## **Park Lane improvement scheme**

\* *Proc. Instn civ. Engrs*, vol. 29, October 1964, pp. 293–340.

FIG. 25. DISTORTION OF ESCALATOR TUNNEL DURING EXCAVATIONS

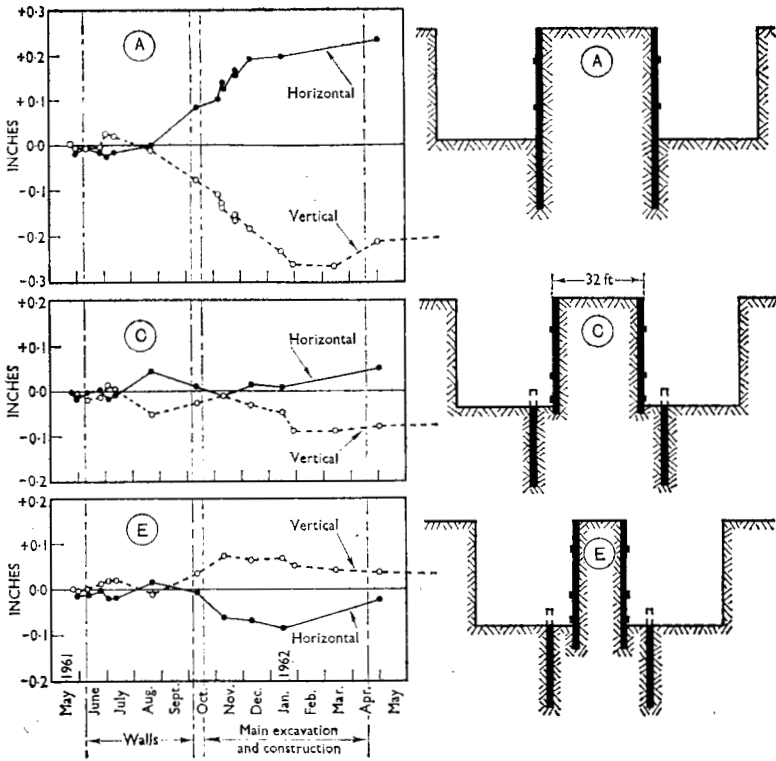
208. Three typical vertical cross sections, A, C and E, through the escalator tunnel and the underpasses and also the changes in the vertical and horizontal diameters of the tunnel plotted against time were shown in Fig. 25. The positive sign represented an increase in diameter. Between June and October 1961 the ICOS and bored pile walls were constructed and from October 1961 to April 1962 the bulk excavation for the underpasses and their main construction was carried out.

209. Section A was one of the most critical sections where the tunnel was situated abreast of the underpass and its construction had led to an appreciable squatting of the tunnel lining—a maximum change in diameter of over  $\frac{1}{4}$  in. The reverse movement in the vertical diameter shown in March–April 1962 was the only significant rectification of the squatting action brought about by increasing the lateral load in the strutting system and was mentioned in § 40(a) of the Paper.

210. At Section C the movements associated with the walls had been larger than at the other sections on account of their position relative to the tunnel and the greater depth of the tunnel.

211. At Section E, on account of the depth of the tunnel relative to the underpass, the horizontal diameter of the tunnel had at first decreased during the bulk excavation, but as the excavation became deeper, the horizontal diameter had increased. This was a typical example of the response of a tunnel lining to the changing shape and position of a surface excavation.

213. At each of the sections shown in the figure there was no bulk excavation immediately alongside the escalator during the period June–October 1961 when the

walls were being constructed alongside, but bulk excavation was taking place upstream and downstream of the area excavated in alternate bays and this affected the diameters of the tunnels at each section to a minor degree. The diameters of the tunnel had changed by a maximum amount of about 0.09 in. at Section A during this period, but Dr Ward did not think that the amount associated with the adjacent wall construction amounted to more than about 0.05 in. On this site the movements were unlikely to have been any greater if plain water had been used in the trenches during the wall construction in place of the Bentonite slurry.
